Tesla, Inc. Service Bulletin		<i>Install Ferrites to Reduce Static Noise From A-pillar Tweeters</i>	
SB-19-17-014 December 13, 2019					
Classification		Section/Group		Mobile Service	
Repair Bulletin		17 - Electrical		Available (where permitted)	
Model Year	Model	Country/Region		Version	
2016 - 2018	Model S, Model X	All		Autopilot HW2 or later with Tegra MCU	
The model(s) and model year(s) listed are a general approximation of the affected VIN list. Refer to the VIN/Bulletin Tracker or Customer/Vehicle profile to determine applicability of this bulletin for a particular vehicle.

Figure 2

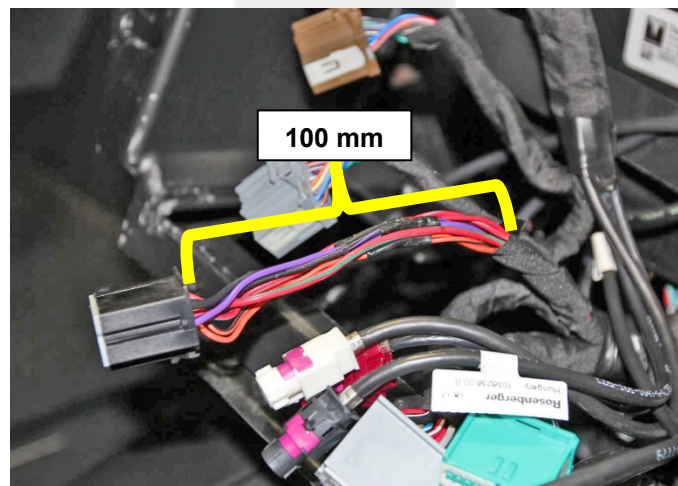
4. Remove approximately 100 mm of harness tape from the connector's harness (Figure 2).

**NOTE:** Remove enough harness tape to allow installation of both ferrites.

Figure 3

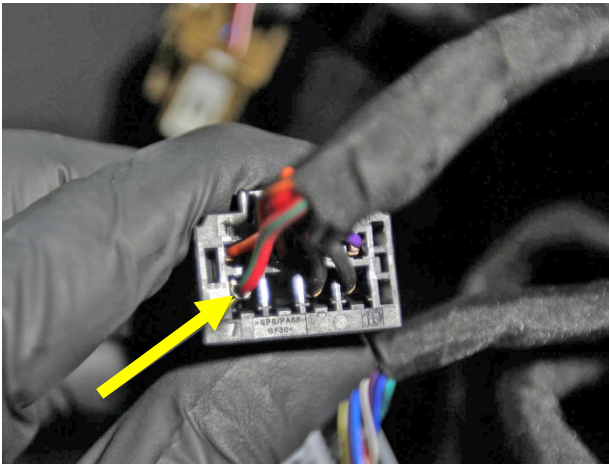
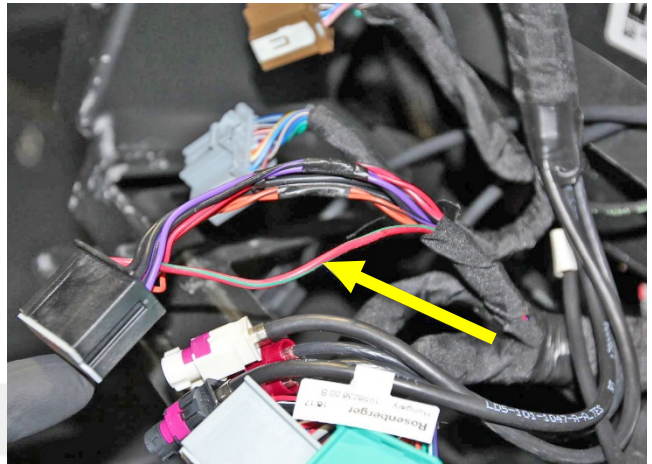
5. Identify the wire that connects to pin 7 on the connector (Figures 3 and 4).

Figure 5

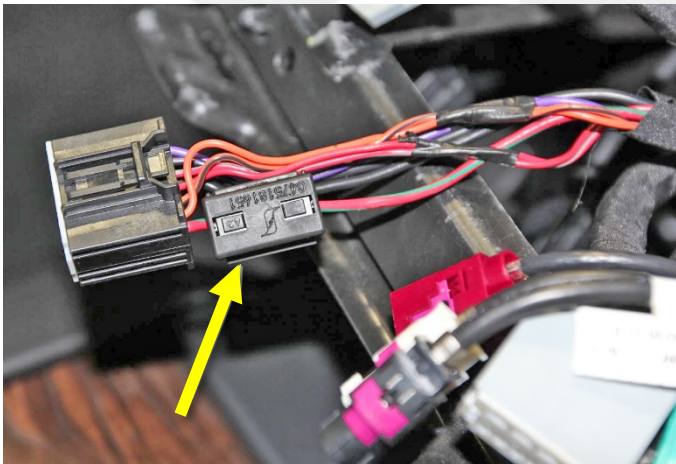
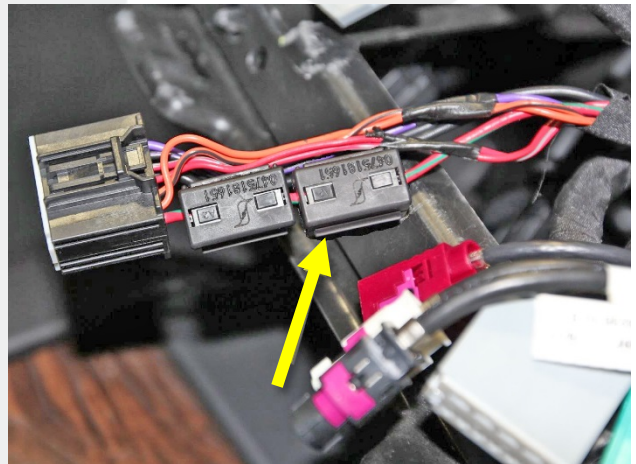
6. Position the first ferrite on the pin 7 wire as close to the connector as possible and then install the second ferrite as close as possible to the first ferrite (Figures 5 and 6).

Figure 7

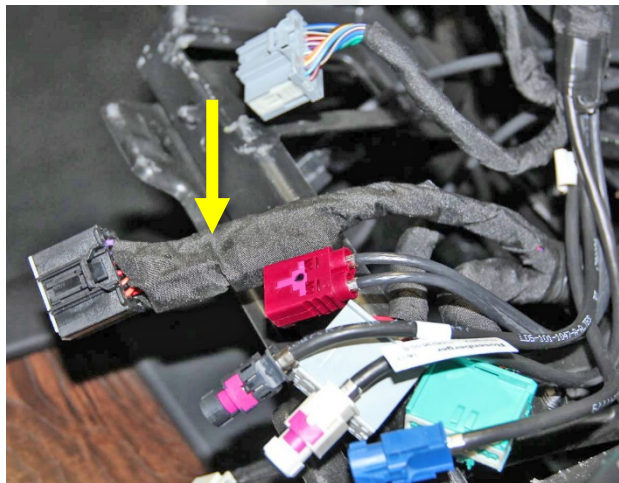
7. Wrap the harness and ferrites with harness tape to secure the ferrites in place and avoid noise and vibration issues (Figure 7).
